## ***Interactive comment on “Global scale human pressure evolution imprints on sustainability of river systems” by Serena Ceola et al.***

**Serena Ceola et al.**

Received and published: 11 June 2019

**Fig. 1.** Standardized human pressure on rivers: preliminary results using time varying discharge data to compute the evolution of human pressure on river systems across four catchments in China and Myanmar.

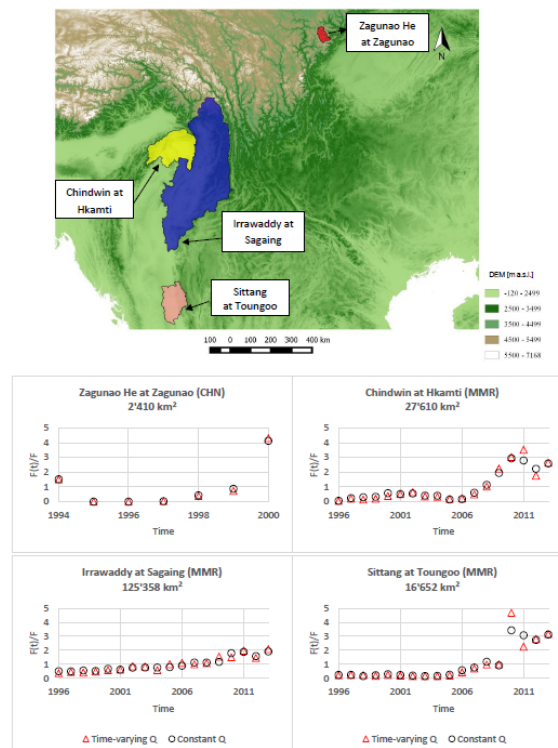
*\*\*\*Why normalize by river discharge?\*\*\* It seems that changes in pressure on river systems (DHPR) are mathematically independent of a location's discharge (since DHPR looks at relative changes and runoff is assumed constant per location). Thus, the “Differential Human Pressure on Rivers” solely quantifies changes in nightlight data along a river network. This is not wrong, but this does not match the description that is used throughout the paper.*

**We normalized by river discharge to distribute human presence and activity on natural available discharge, following the approach developed by Vörösmarty et al. (2010). DHPR is based on the analysis of the temporal evolution of standardized human pressure on rivers  $F_i(t)$ , as defined by Eq. (10) in the original manuscript. Standardized human pressures, and thus DHPR, are a function of**

the (i) ratio between human presence and activity,  $HP_i$ , and discharge,  $Q_i$ , and (ii) its minimum and maximum values, which consider both HP and Q. As a consequence, DHPR is not totally independent of Q. Our approach, as defined in this manuscript, considers stationary discharge. However, it is planned in the near future to consider time varying natural flows, to explicitly embed variations in both drivers. As an example, we performed a preliminary study on a few catchments across China and Myanmar, using discharge data provided by GRDC (Global Runoff Data Centre). Standardized human pressures on rivers are reported in Fig. R1, where a comparison between time varying and constant discharge is shown.

**Fig. 2.** Global distribution of (a) relative change in human pressure on river systems, DHPR (% per year), (b) long term average standardized human pressure on river systems,  $\bar{F}$ , where the value at the outlet

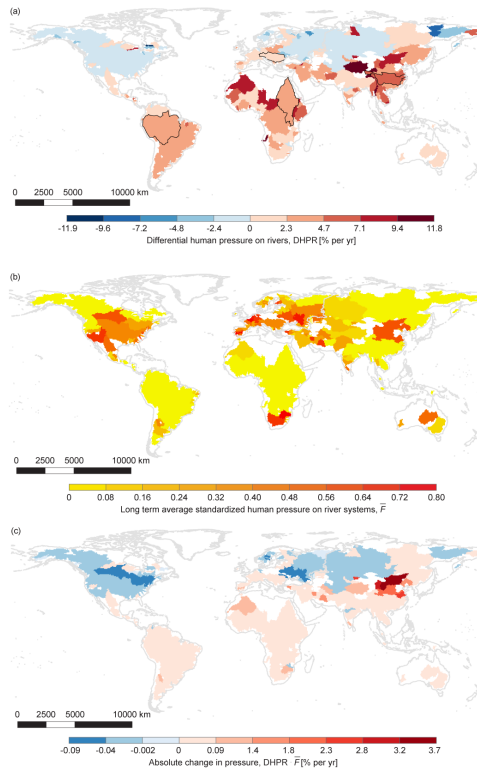
*\*\*\*What makes a hotspot a hotspot\*\*\* Hotspots can be identified based on absolute pressure, or changes in pressure. The focus in this paper seems on the latter. However, these are all “relative changes” in pressure, but is a relative change really relevant when the “absolute pressure” is very low?\**

Thanks for this comment. To better explain this issue and reply to your question, we show in Fig. R2 a comparison among (a) the relative change in pressure, DHPR, (b) the long term average standardized human pressure on river systems  $\bar{F}$ , where the value at the outlet is uniformly distributed across each river basin, and (c) the absolute change in pressure, as the product between DHPR and  $\bar{F}$ . Marked absolute changes in pressure are evident only for river basins with relatively high standardized human pressures. These absolute changes, expressed as % per year, are evidently proportional to absolute pressures and thus it is not possible to compare trends across basins. We used normalized values of human pressure in order to compare trends at global scale, independently from absolute human pressure values, which are influenced by catchment size, human presence and activity (namely, the sum of nightlights) and discharge.
